STAFF REPORT
WEST ALLIS PLAN COMMISSION
Wednesday, October 25, 2023
6:00 PM

- 2A. **Conditional Use Permit for SoNa Lofts Phase 2, a proposed 5+ Unit Dwelling, at 6600 W. Mitchell St.**
- 2B. **Site, Landscaping, and Architectural Design Review for SoNa Lofts Phase 2, a proposed 5+ Unit Dwelling, at 6600 W. Mitchell St. (Tax Key No. 454-0656-000)**

2 WEST ELEV.
SCALE: 1/16" = 1'-0"

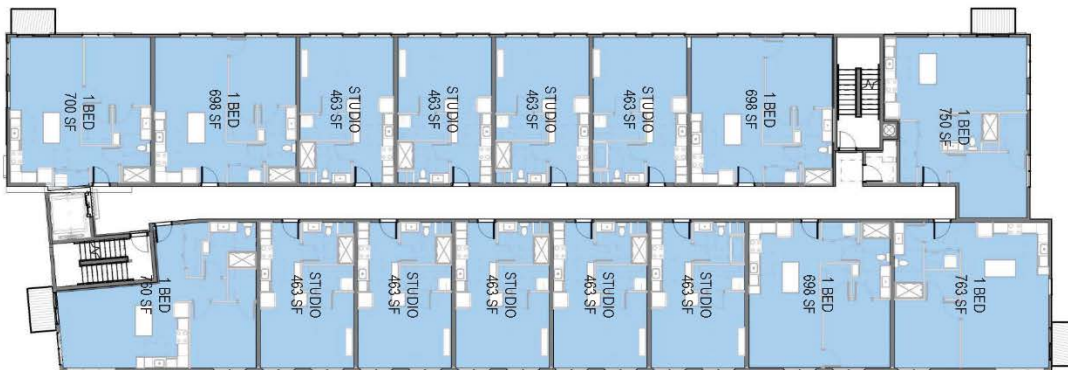
The west façade

includes a proposed mural on the exposed first-story. Lining the west façade's upper floors are a collection of windows for the apartment units. End units include balconies. The design of this façade is sleek and contemporary, while also intending to honor the historical legacy of industry. Staff is

recommending revisions to this façade that still honor the industrial legacy yet create additional visual interest. This may include vertical features to break up the façade, inseting/offsetting to create depth, ornamental overhangs, etc.

1. Revised Site, Landscaping, and Architectural plans submitted to show the following: a) at least 1 outdoor bicycle parking spaces and 10 indoor bicycle parking spaces to comply with Sec. 19.44 Vehicle Parking; b) show passageway from accessible parking stall to entrance door; c) additional design elements on the west façade for enhanced visual interest
2. A surety bond or other form of security as required under Sec. 12.13(14) of the Revised Municipal Code in the amount of 125% of landscaping and screening shall be executed by the applicant prior to the issuing of a building permit.
3. Common Council approval of the Conditional Use permit.
